Work Order ID 75602

Item Name: Crosstube Fwd

DART AEROSPACE LTD	Work Order:	75602
Description: Crosstube High Fwd (205/212/412)	Part Number:	D212-664-101
Inspection Dwg: D212-664-141	Rev: D	Page 1 of 1

DRAWING NO. D212-664-141	TITLE XTUBE ASSY (205/212/412 HI FWD)	REV. D	DART AEROSPACE LTD ENGINEERING ORDER		D.E.O. NO. D212-664-141-D-1	SHEET NO. SHEET 1 OF 2	SCALE NTS
DRAWN	CHECKED	MP	MFG. APPR.	EE	APPROVED	MP	DE APPR.
DATE 11.04.07	DATE 11.04.11		DATE 11.04.12		DATE 11/04/12		DATE 11.04.12

**D212-664-141/-141B
ASSEMBLY DETAIL**

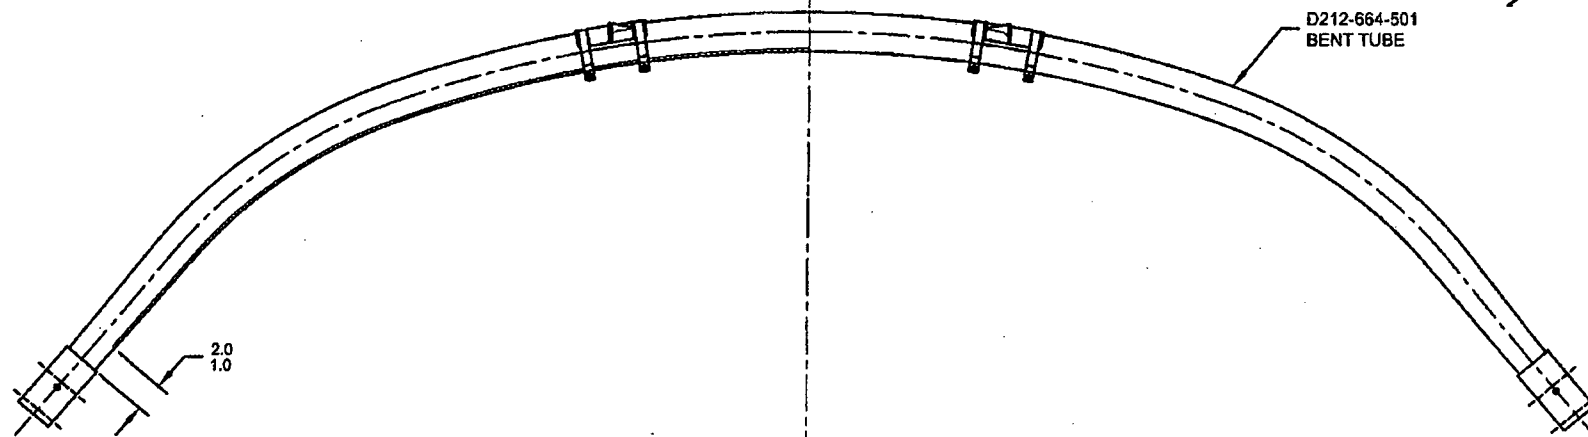
PURPOSE:

ADD AN INSPECTION WINDOW TO UNDERSIDE OF CROSSTUBE.

NOTES 2 OF SHEET 1 IS AMENDED AS FOLLOWS:

- 2) FINISH: CHEMICAL CONVERSION COAT PER DART QSI 005 4.1
PRIME INSIDE AND OUTSIDE PER DART QSI 005 4.2
MASK UNDERSIDE OF CROSSTUBE AS SHOWN (HATCHED AREA) AND
PAINT OUTSIDE PER DART QSI 005 4.2
REMOVE MASKING AND APPLY CLEAR COAT

- 2) FINISH: CHEMICAL CONVERSION COAT PER DART QSI 005 4.1
PRIME INSIDE AND OUTSIDE PER DART QSI 005 4.2
PAINT OUTSIDE PER DART QSI 005 4.2

MASK AREA PRIOR TO PAINTING.
REMOVE MASKING AFTER PAINT
AND APPLY CLEAR COAT
